January 24, 2003
L-03-004

Subject: Beaver Valley Power Station, Unit No. 1 and No. 2
BV-1 Docket No. 50-334, License No. DPR-66
BV-2 Docket No. 50-412, License No. NPF-73
Reply to Request for Additional Information Regarding
60-Day Response to Bulletin 2002-01

Reply to Request for Additional Information Regarding Beaver Valley Power Station (BVPS) Units 1 and 2 60-Day Response to NRC Bulletin 2002-01 “Reactor Pressure Vessel Head Degradation and Reactor Coolant Pressure Boundary Integrity”

Figure 4A

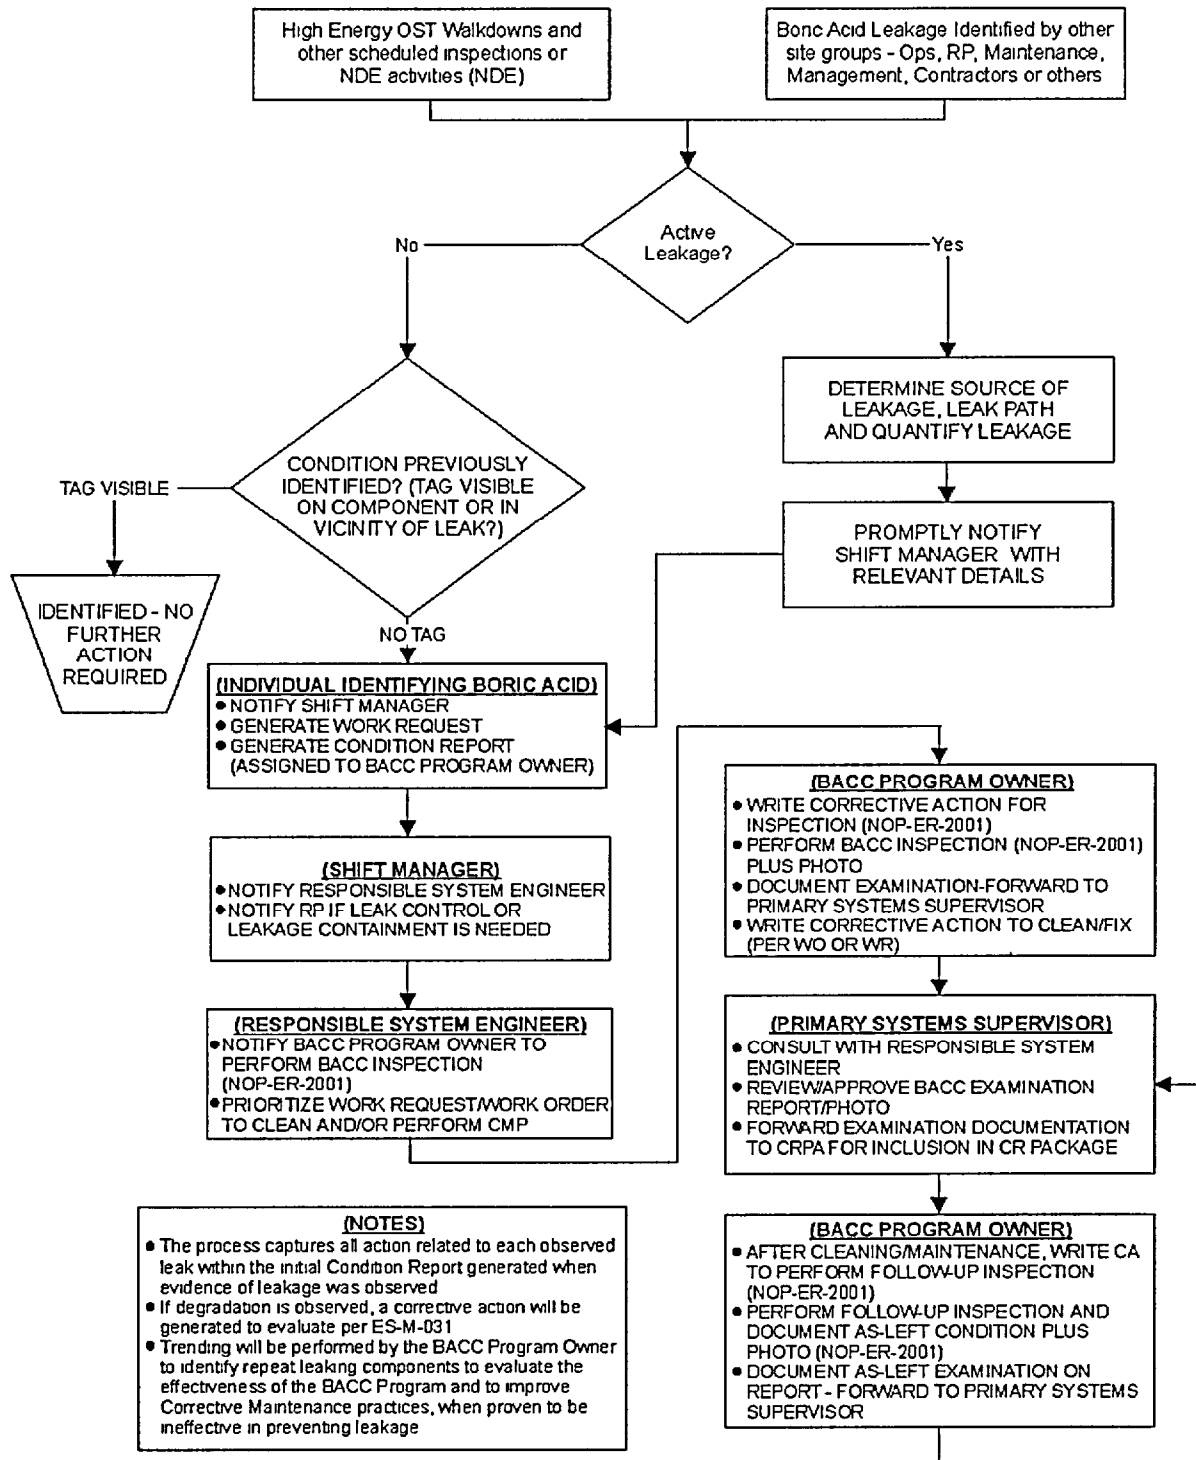
4. **Describe the evaluations that would be conducted upon discovery of leakage from mechanical joints (e.g., bolted connections) to demonstrate that continued operation with the observed leakage is acceptable. Also describe the acceptance criteria established to make such a determination. Provide the technical basis used to establish the acceptance criteria. In addition,**
 - a. **if observed leakage is determined to be acceptable for continued operation, describe what inspection/monitoring actions are taken to trend/evaluate changes in leakage, or**
 - b. **if observed leakage is not determined to be acceptable, describe what corrective actions are taken to address the leakage.**

Boric acid leakage process flow charts were developed for inclusion in 1/2-ADM-2112, "Boric Acid Corrosion Control," and are attached for your information (see Figures 4A and 4B). These flow charts clearly identify the process and the actions to be taken.

If the observed leakage is determined to be acceptable for continued operation, the actions and monitoring for trending and evaluating are described in our procedure 1/2-ADM-2112. A summary of the process is provided in the attached flowcharts (see Figures 4A and 4B).
